Attachment No. 1
SIGNALS NO.1

TECHNICAL COMMITTEE RECOMMENDATION

TOPIC: **Proposed new Chapter 4M Traffic Control Beacons For Pedestrians**

Figure 4M-1. Guidelines for the Installation of Pedestrian Beacons on Low Speed Roadways

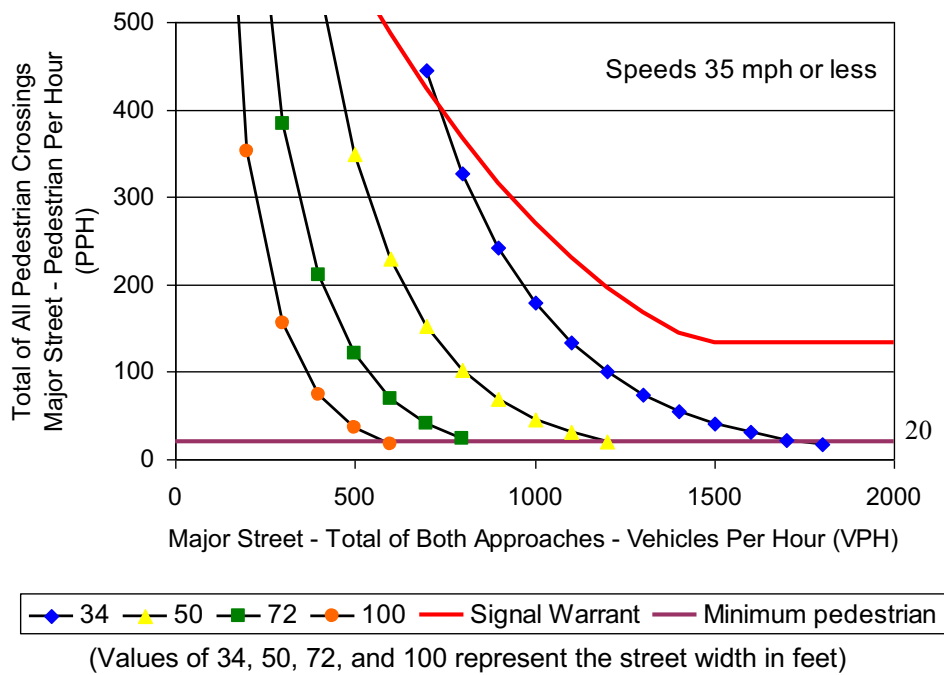
For a major street where the posted or statutory speed limit or the 85th-percentile speed is 60 km/h or less or is 35 mph or less, the need for a pedestrian beacon should be considered if the engineering study finds that the plotted point representing the vehicles per hour on the major street (total of both approaches) and the corresponding total of all pedestrians crossing the major street for 1 hour (any four consecutive 15-minute periods) of an average day falls above the applicable curve in Figure 4M-1 for the length of the crosswalk (measured in feet).

Figure 4M-2. Guidelines for the Installation of Pedestrian Beacons On High Speed Roadways

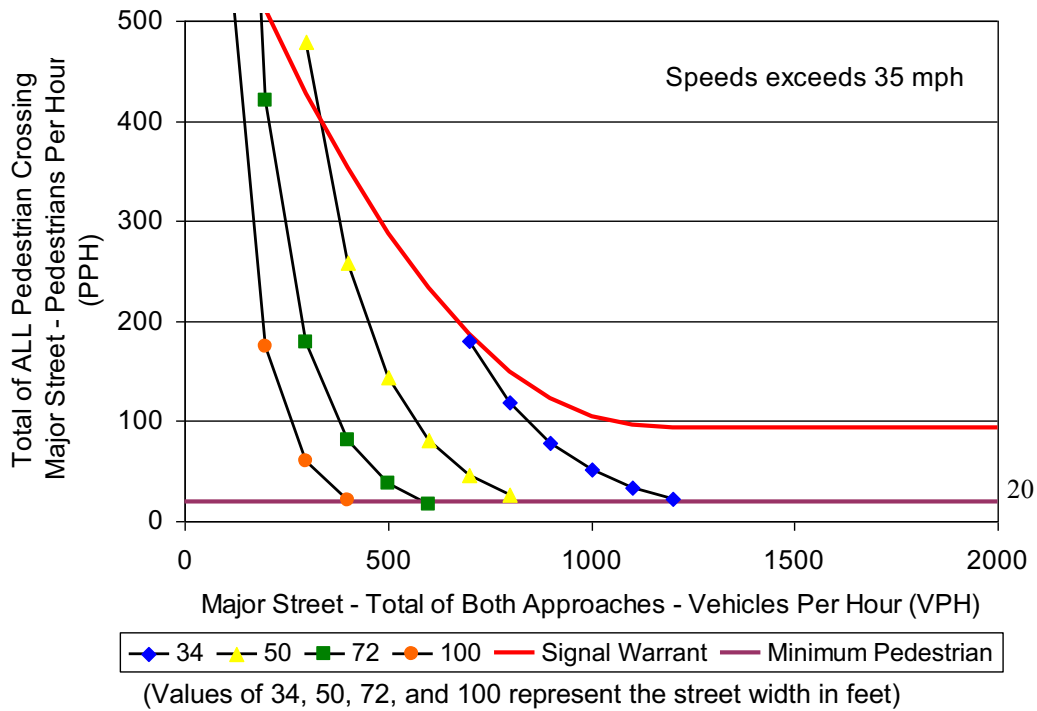
For a major street where the posted or statutory speed limit or the 85th-percentile speed exceeds 60 km/h or exceeds 35 mph, the need for a pedestrian beacon should be considered if the engineering study finds that the plotted point representing the vehicles per hour on the major street (total of both approaches) and the corresponding total of all pedestrians crossing the major street for 1 hour (any four consecutive 15-minute periods) of an average day falls above the applicable curve in Figure 4M-2 for the length of the crosswalk (measured in feet).

[Note: Metric versions of Figures 4M-1 and 4M-2 also need to be developed.]

Figure 4M-3. Example of Sequence for a Pedestrian Beacon

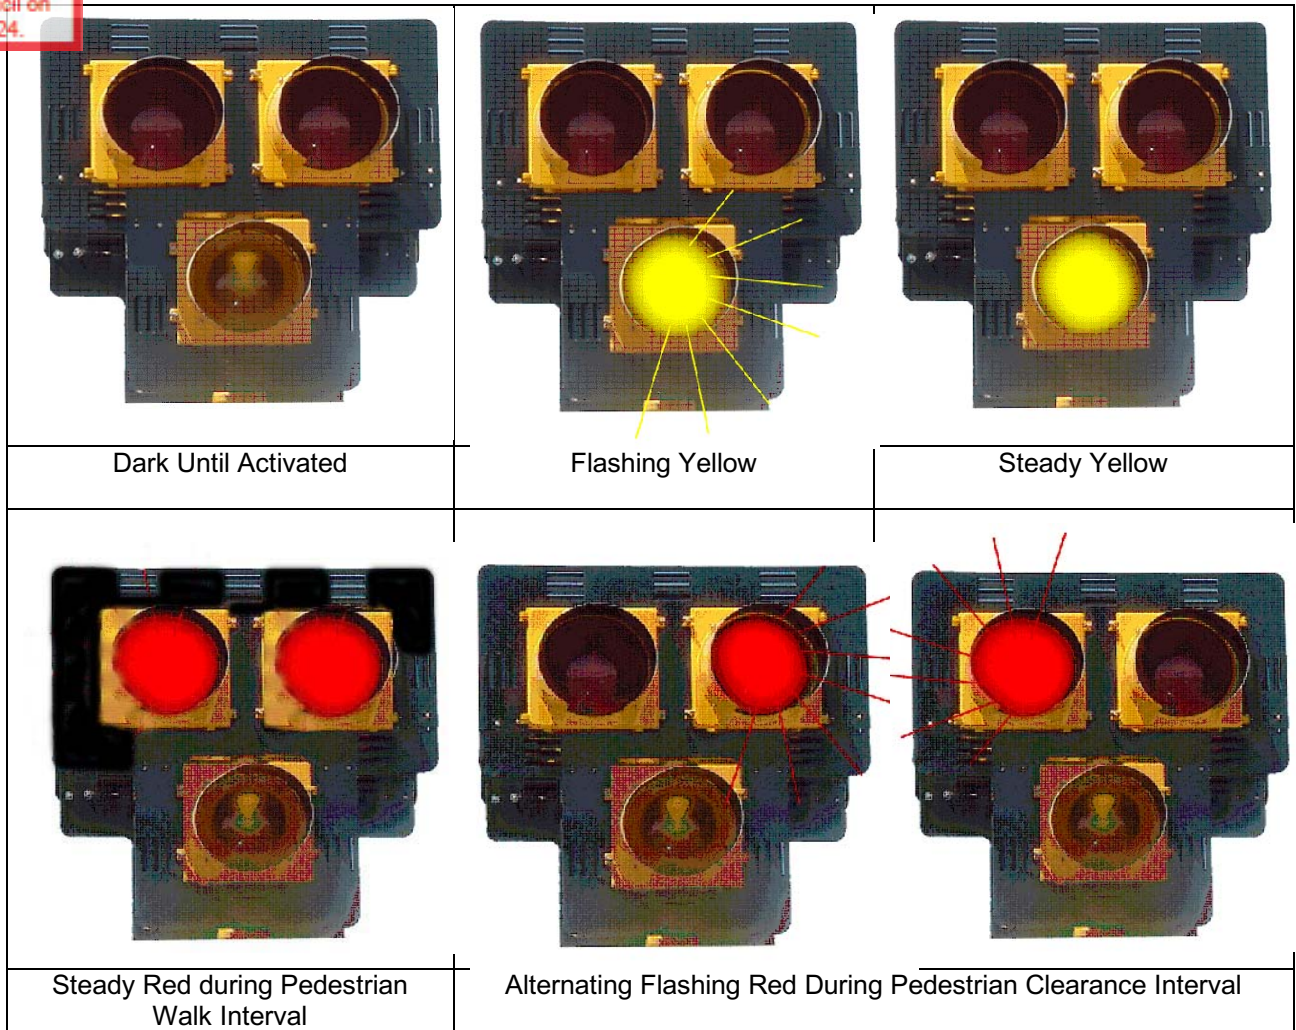
A pedestrian beacon shall consist of three signal sections, with a CIRCULAR YELLOW signal lens centered below two horizontally aligned CIRCULAR RED signal lenses (see Figure 4M-3).

Upon actuation by a pedestrian, a pedestrian beacon shall display a flashing CIRCULAR YELLOW signal indication, followed by a steady CIRCULAR YELLOW signal indication, followed by both steady CIRCULAR RED signal indications during the pedestrian walk interval, followed by alternating flashing CIRCULAR RED signal indications during the pedestrian clearance interval (see Figure 4M-3). Upon termination of the pedestrian clearance interval, the pedestrian beacon shall revert to a non-illuminated condition.
